Sun**PRODUCTION CHANGE
and
SERVICE BULLETIN****"NEW"
KNOB AND LEAD-SCREW
'FOR CARBON PILE'**

MARCH 1981

"NEW" CARBON PILE KNOB ASSEMBLY AND LEAD-SCREW
#7009-1457 #0784-0001

**S C R E W
#0784-0001**

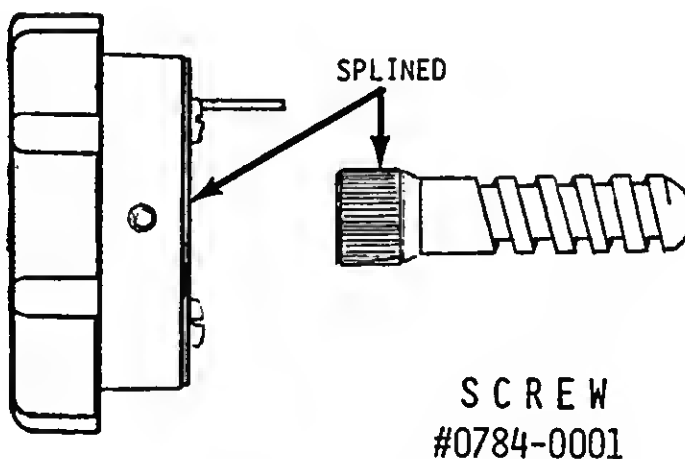
DUE TO FIELD REPORTS REGARDING SLIPPAGE BETWEEN THE CARBON PILE'S LEAD SCREW AND CONTROL KNOB, A "NEW" SPLINED LEAD SCREW (#0784-0001) AND A MATCHING SPLINED CONTROL KNOB (#7009-1457) HAVE BEEN RELEASED FOR ALL SERVICE AND "NEW" PRODUCTION VAT-4D TESTERS.

NOTE: THE "NEW" KNOB AND THE "NEW" LEAD-SCREW MUST BE USED AS A SET WHEN SERVICING TESTERS MANUFACTURED PRIOR TO 2ND QUARTER 198D PRODUCTION (DATE CODE "20").

ALL VAT-4D TESTERS DATE CODED "20" OR LATER WILL INCORPORATE THIS CHANGE.
